**SERVICING DESIGN BRIEF
AND
STORMWATER MANAGEMENT
REPORT**

1420 EARL ARMSTRONG ROAD

TOWN SQUARE CENTRE

**SITE PLAN APPLICATION
FILE No. DO7-12-14-0067**

FILE NO D07-12-14-0067
GRADING PLAN

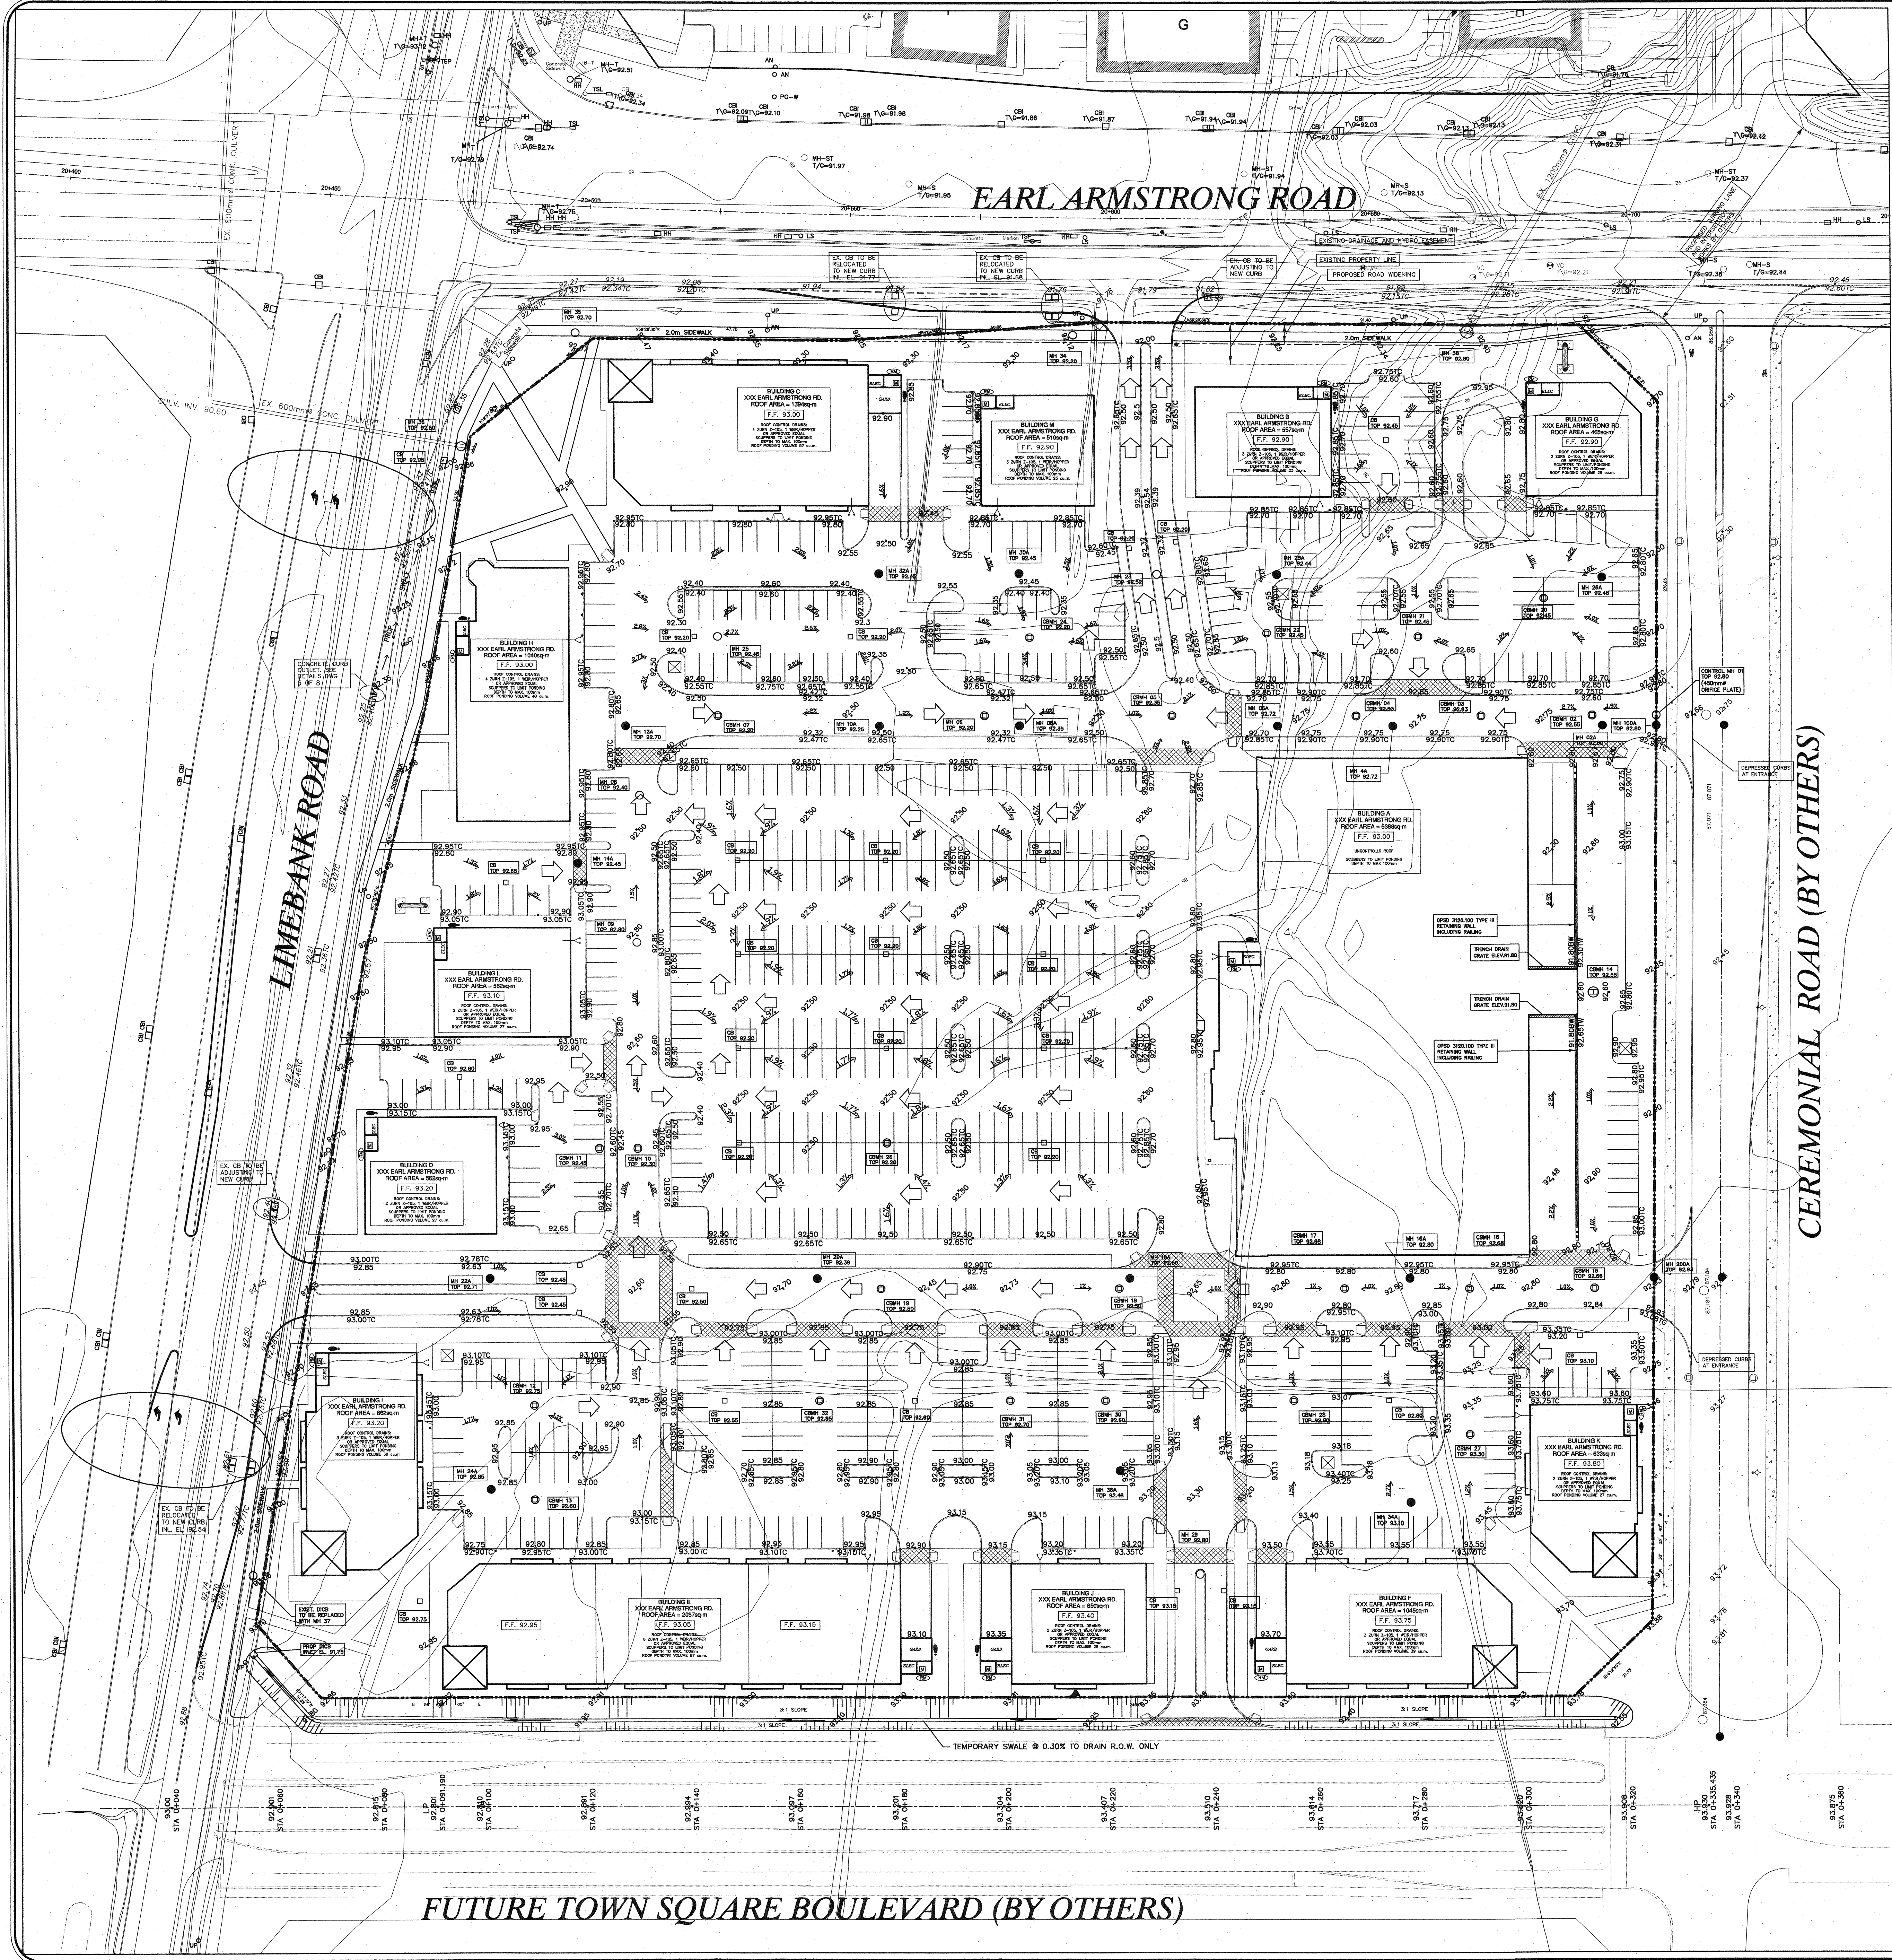
58. Provide existing /proposed grades on Limebank Road & Earl Armstrong (edge of pavement, top of curb etc in order that the sidewalk & major overland flow route can be designed.

60. Review servicing comment regarding lack of cover over the upper end of sanitary sewer system.

62. Entrances exceed 2% slope please review with Asad Yousfani and revise as required.

64. Provide depressed curbs across the Collector 'D' per city Dwg. SC7.1

Response: *Grades have been added*

Response: *Grades have been revised and insulation added as shown on the drawings*

Response: *Grades have been revised as shown on the drawings*

Response: *Shown on drawings*

FILE NO D07-12-14-0067
SERVICING PLAN

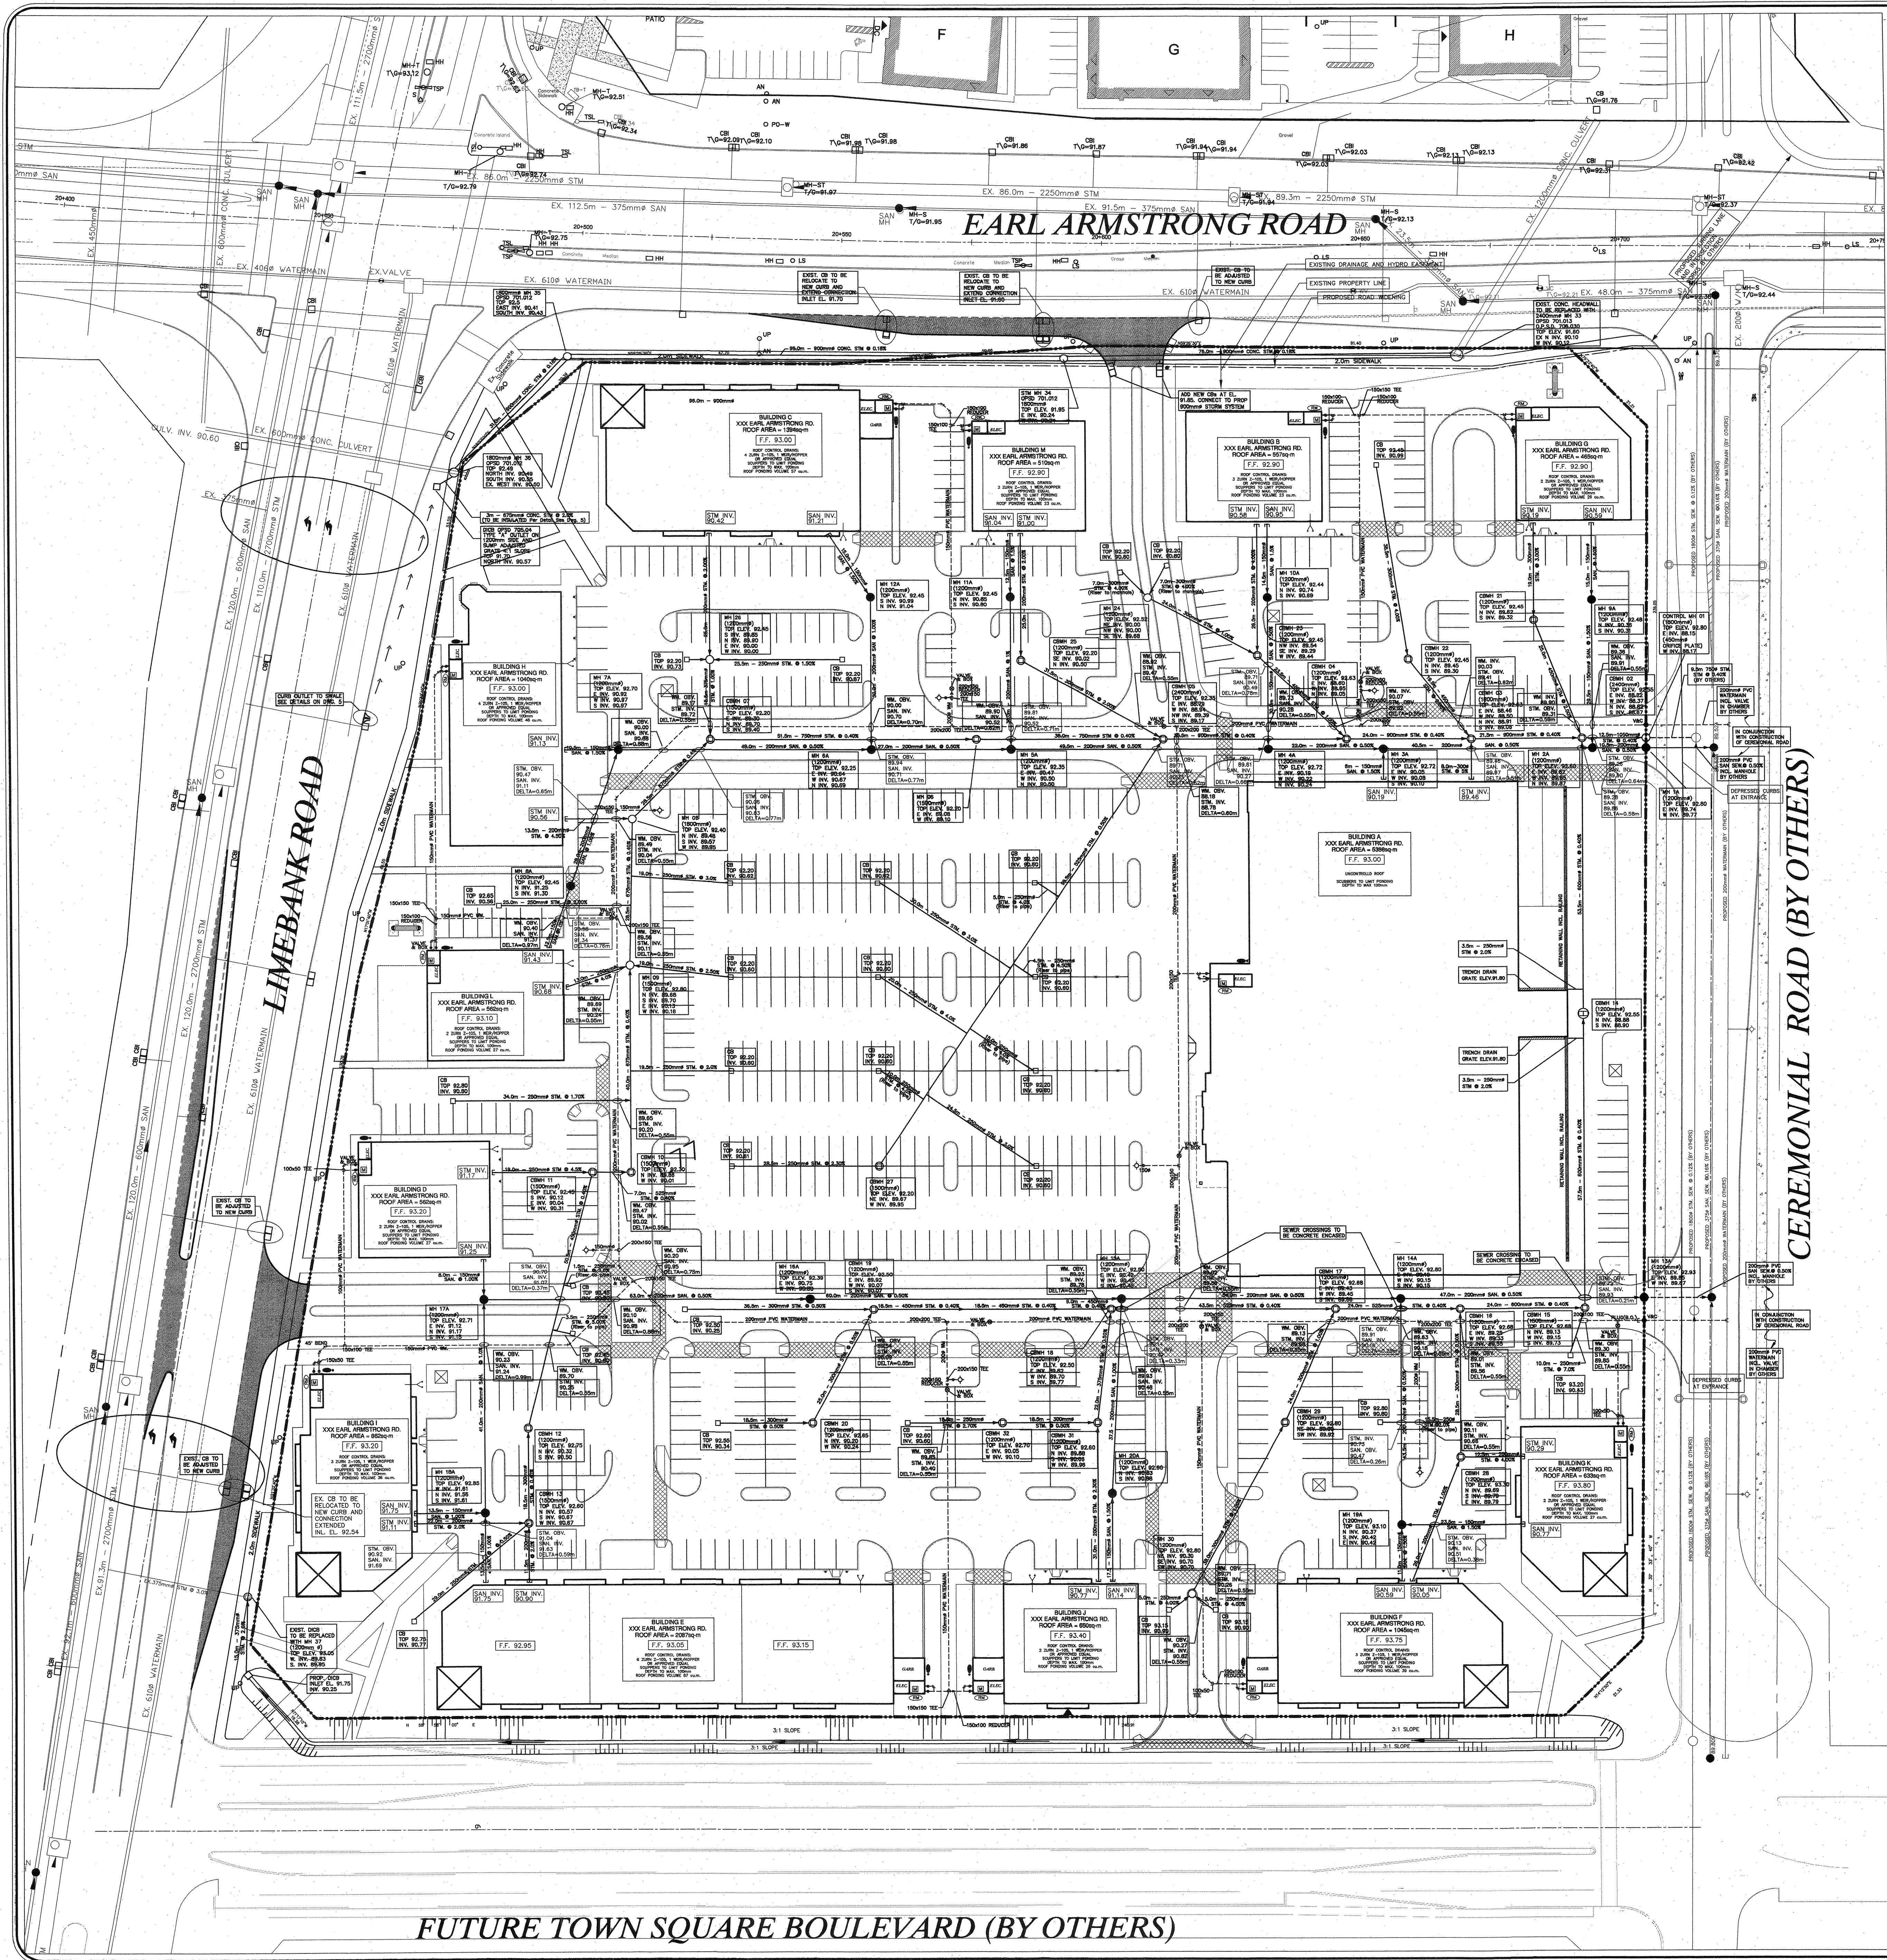
67. Building I, D and L are lacking hydrants for the sprinkler system coverage, add 1 to 2 hydrants as needed.

68. Revise all watermains from 90° bends to 2-45° bends or combination less than 90°

69. Show location of Siamese connection for Building “B”

70. Add a note the two water service connections to property line “by others”

73. Per Paterson Group’s recommendation, add clay dykes to the servicing plan.

76. Review 200ø sanitary design, upper end of system does not have adequate cover (Building C,H,L,D,I,E and J) plus if insulation is required provide a typical section on Dwg 5 of 8. Designer may have to review flatter grades on the mainline sewers.

Response: *Hydrants have been added*

Response: *Watermains have been revised*

Response: *Siamese connection is added*

Response: *As shown on drawings*

Response: *Notes added to drawings 2 of 8 and 5 of 8*

Response: *Grades have been revised and insulation added as shown on the drawings*
